JENNINGS MUSICAL INDUSTRIES LTD

T60 AMPLIFIER CIRCUIT

05/062

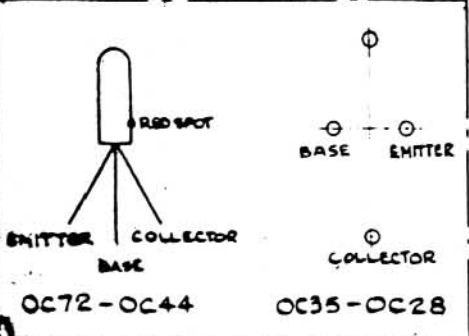
REMOVE LINK WHEN VIBRATO UNIT IS FITTED.

C15 ADDED, & CONNS. TO VIBRATO UNIT	4	10/10/63	P.U.
CONNECTION MODIFIED - DELETED	3	15/7/63	MJ
REDRAWN	2	28/1/63	MJ

C17 & C18 ADDED R34 & R35 ADDED R12 WAS 100K C5 WAS .0047μF	10	30.9.65	1/1
R33 & C15 ADDED R14 WAS 330K	8	17-12-64	1/2/64
LINK ADDED	7	21-9-64	
GENERAL MODIFICATIONS	6	18.3.64	
TR4 BECOMES OC72 - OC44	5	10-2-64	1/1
